15-DAY COMMENT PERIOD MODIFICATIONS
FOR
PROPOSED BUILDING STANDARDS
OF THE
DIVISION OF THE STATE ARCHITECT ACCESS COMPLIANCE
REGARDING THE FIGURES FOR ACCESSIBLE PARKING OF THE
2007 EDITION OF THE CALIFORNIA BUILDING CODE (CBC)
CALIFORNIA CODE OF REGULATIONS TITLE 24, PART 2, CHAPTER 11B - FIGURES

DSA/AC proposes to update the accessible parking figures to include new language regarding paint stripe color as described in existing Section 1129B.

FIGURES 11B-18A, 11B-18B & 11B-18C

FIGURE 11B-18A - DOUBLE PARKING STALLS

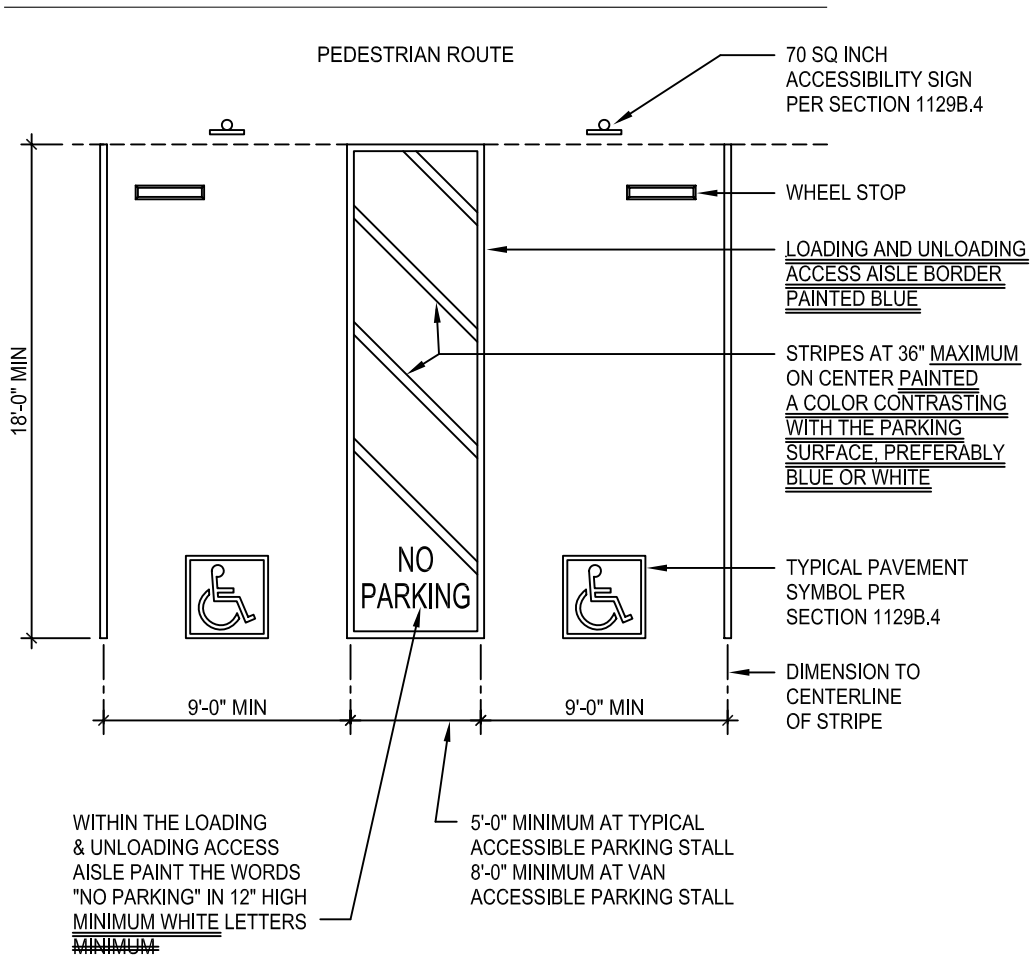
Rationale: Based on a request from Mr. Steven Winkle, who is a member of the California Building Standards Commission, the Division of State Architect – Access Compliance is proposing 15-Day language to add text to the Figures 11B–18A, 18B, and 18C regarding the color of the paint stripping for accessible parking stalls. This will minimize confusion between the figures and written text in Section 1129B.
